ZBA MEETING PACKET

02/09/22

Committee/Board/s	Zoning Board of Appeals
Day, Date, and Time	Thursday, February 09, 2023, at 1:00 PM
Location / Address	4 Fairgrounds Road, Nantucket, MA 02554 **PSF COMMUNITY ROOM & REMOTE PARTICIPATION VIA ZOOM WEBINAR**
Signature of Chair or Authorized Person	Leslie Woodson Snell, Deputy Director of Planning and Zoning Administrator
WARNING:	**IF THERE IS NOT A QUORUM OF MEMBERS OR IF THE MEETING POSTING IS NOT IN COMPLIANCE WITH THE OPEN MEETING LAW, NO DELIBERATIONS MAY TAKE PLACE-BUT THE MEMBERS MAY APPEAR AND ANNOUNCE A NEW SCHEDULE.**

37-21 Kristina & Nicholas Amendolare **8 Bank Street** **Williams**

FIGURE 2 – PROPOSED CONSTRUCTION

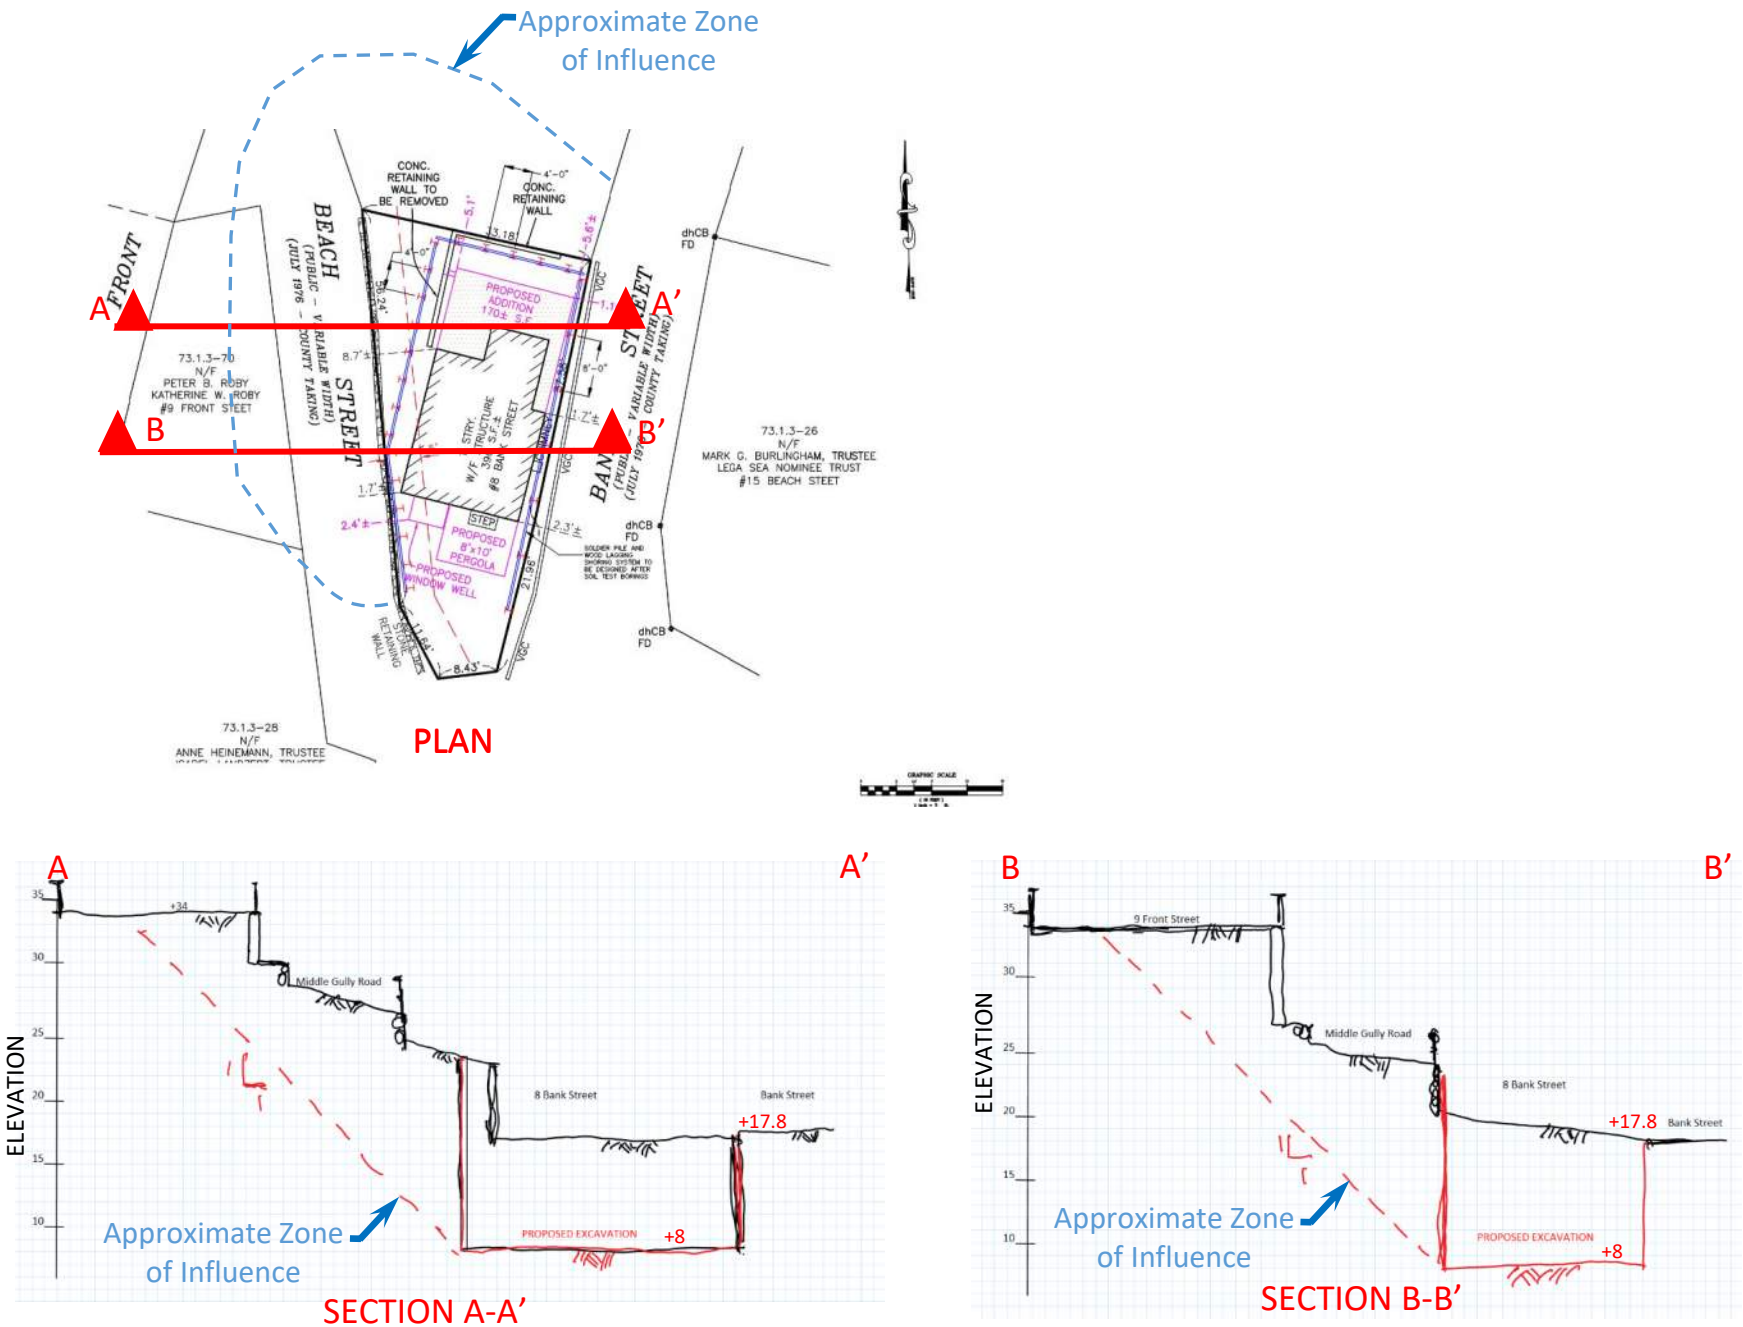
The proposed construction requires a deep excavation to a depth of more than 17 feet immediately below Middle Gully Road and the nearby retaining wall supporting 9 Front Street. Furthermore, the retained ground slopes up to a higher elevation, resulting in increased lateral earth pressures on the SOE system as shown in cross-sections A-A' and B-B' in Figure 2.

In general, even a well-designed and supported excavation has potential to impact ground within a 1:1 (horizontal to vertical) zone of influence from the bottom of the excavation. As illustrated in plan and section on Figure 2, all of Middle Gully Road and most of 9 Front Street are within the potential 1:1 zone of influence of the deep excavation required for basement construction at 8 Bank Street. The structure at 9 Broadway is generally beyond the potential zone of direct influence. As a result, the proposed deep excavation could cause ground loss and instability of the retained ground in a number of ways including but not limited to:

FIGURE 2 – PROPOSED CONSTRUCTION

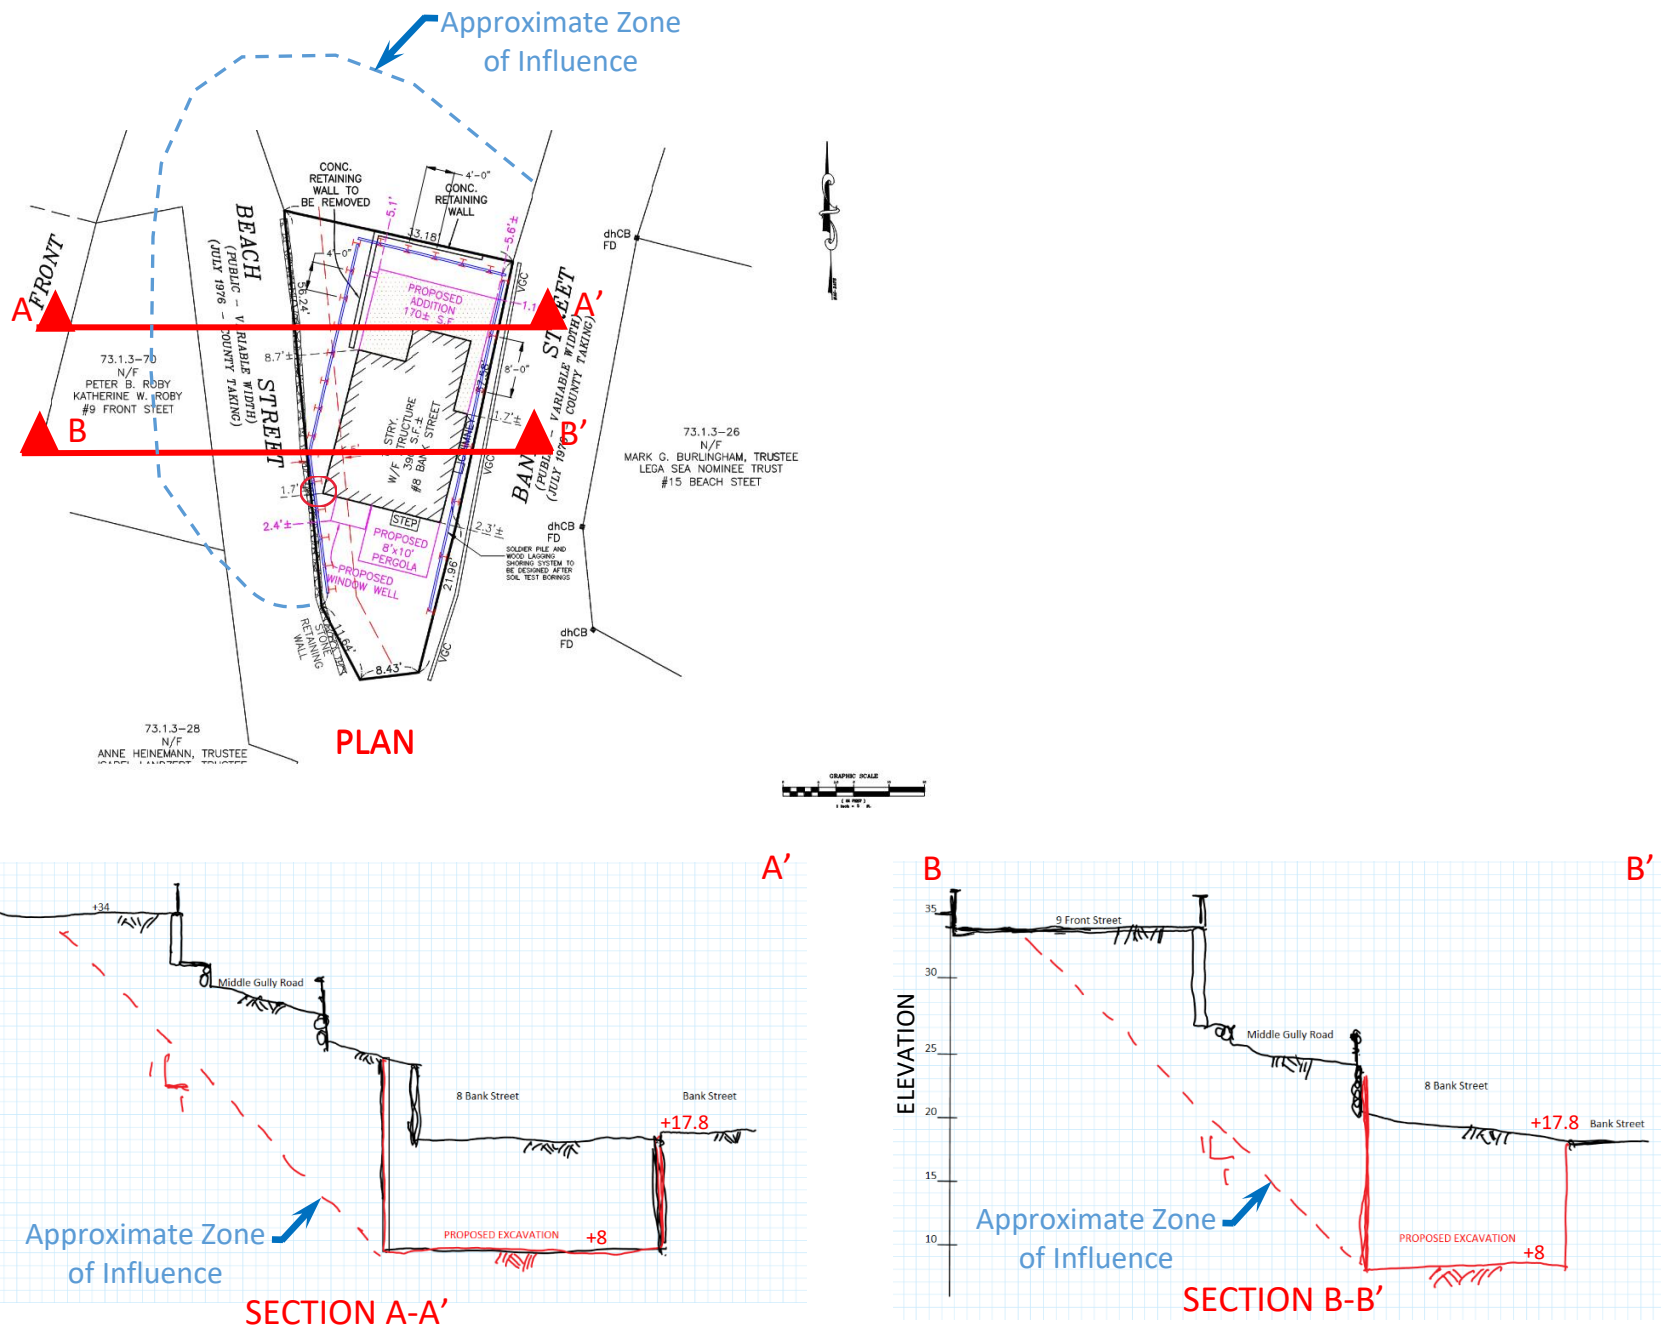
The proposed construction requires a deep excavation to a depth of more than 17 feet immediately below Middle Gully Road and the nearby retaining wall supporting 9 Front Street. Furthermore, the retained ground slopes up to a higher elevation, resulting in increased lateral earth pressures on the SOE system as shown in cross-sections A-A' and B-B' in Figure 2.

In general, even a well-designed and supported excavation has potential to impact ground within a 1:1 (horizontal to vertical) zone of influence from the bottom of the excavation. As illustrated in plan and section on Figure 2, all of Middle Gully Road and most of 9 Front Street are within the potential 1:1 zone of influence of the deep excavation required for basement construction at 8 Bank Street. The structure at 9 Broadway is generally beyond the potential zone of direct influence. As a result, the proposed deep excavation could cause ground loss and instability of the retained ground in a number of ways including but not limited to:

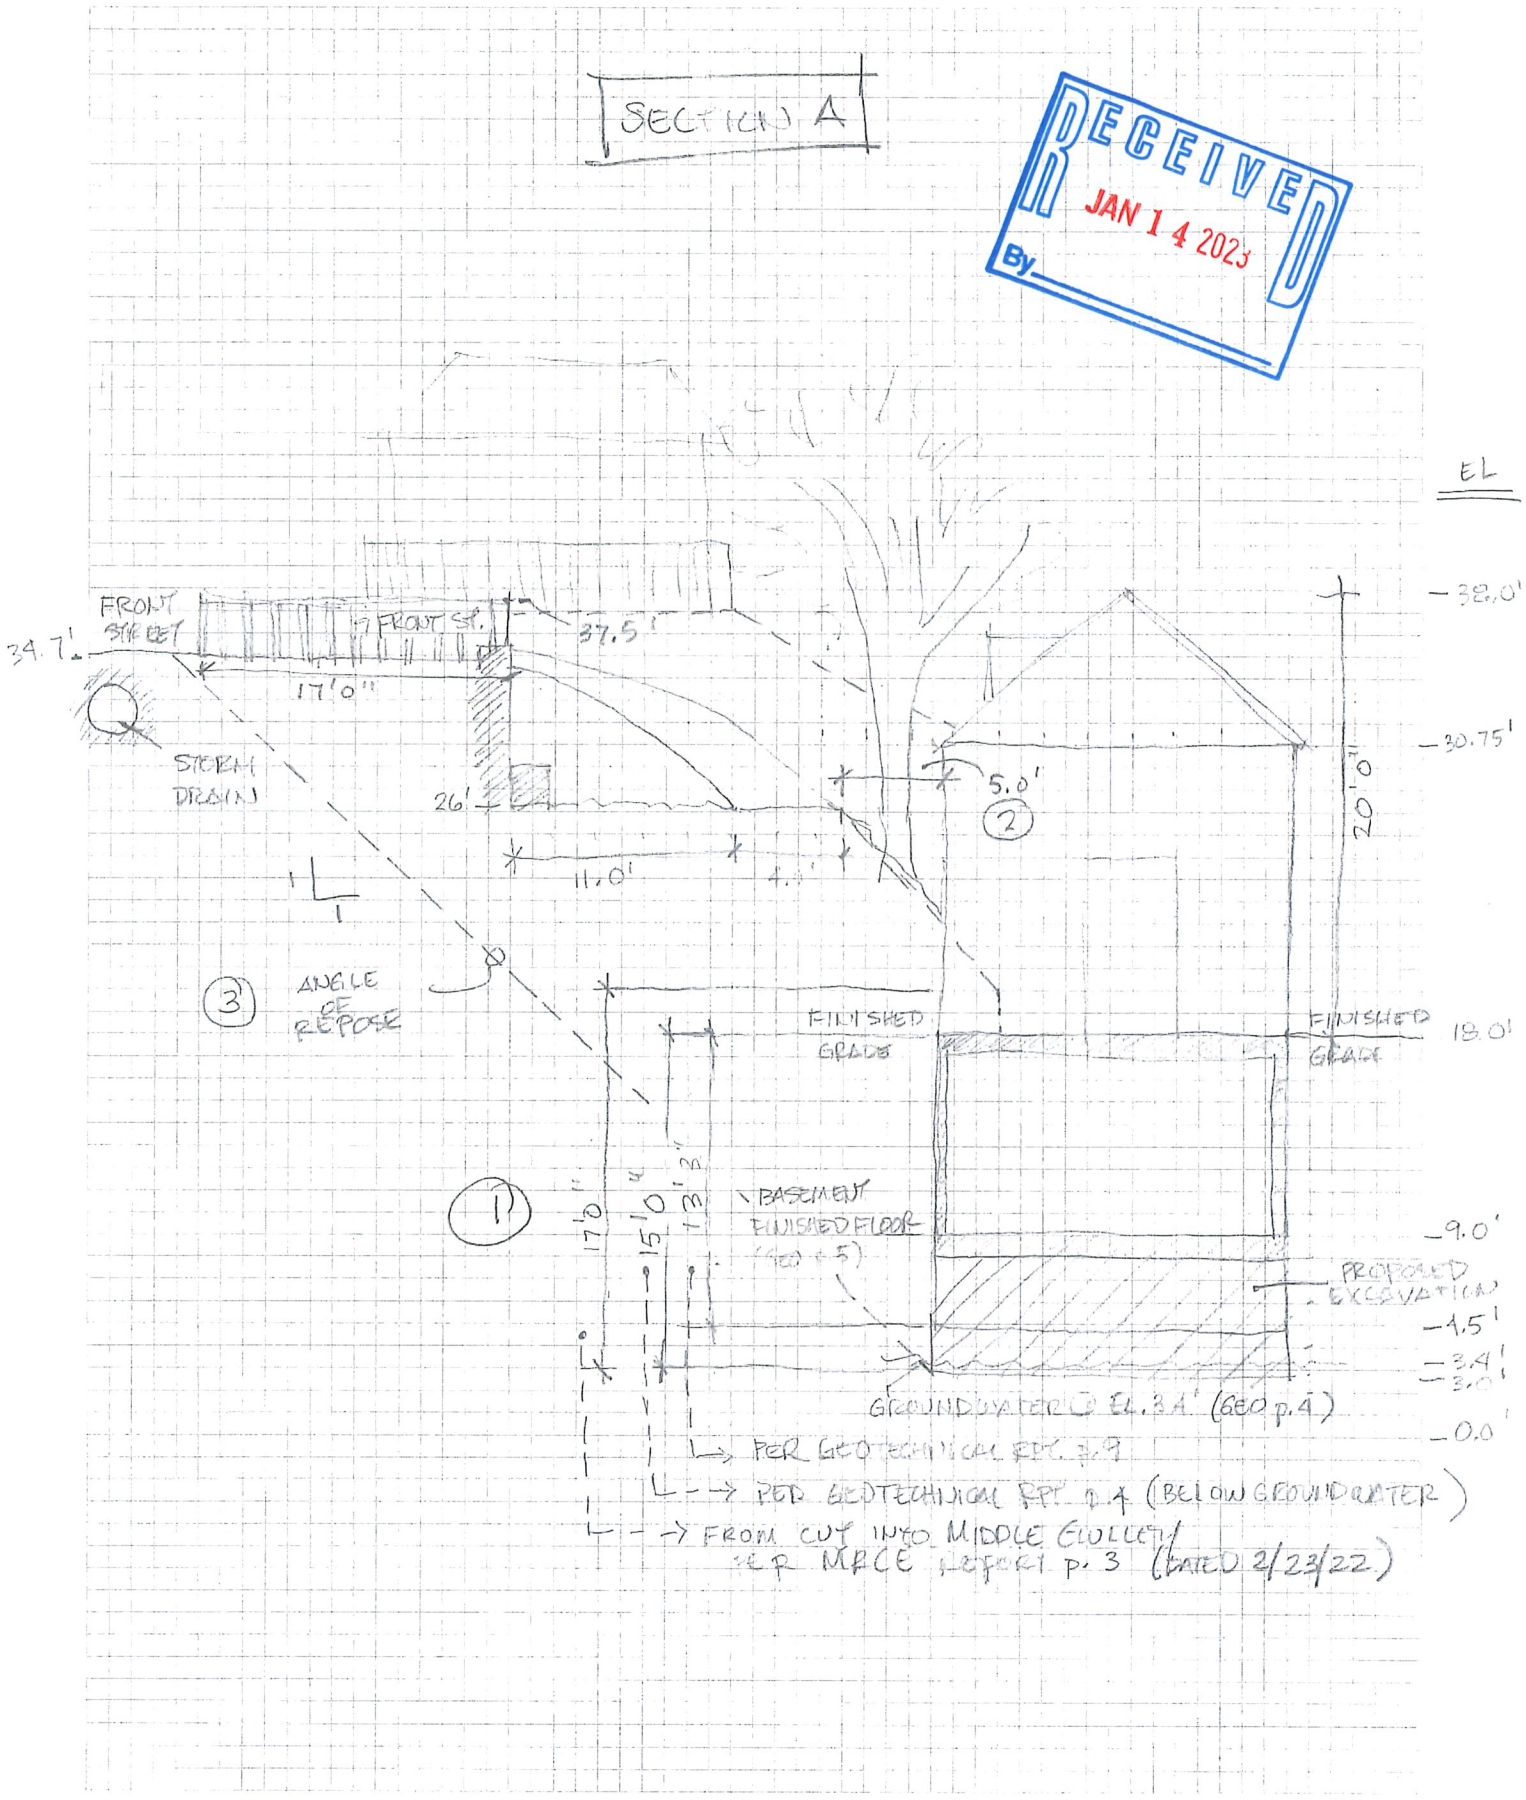
2. **The tree is located in a tight 5'0" space between Middle Gulley and the 8 Bank Street house,** putting both the tree and the stability of Middle Gulley in jeopardy if the tree is damaged or removed during construction.

3. **Due to the Depth of Excavation, the Angle of Repose extends to Front Street** in the westerly direction and could have a similar impact to the north and south of the site. The soil above that 45 degree angle line is prone to sliding and caving into the 8 Bank site.
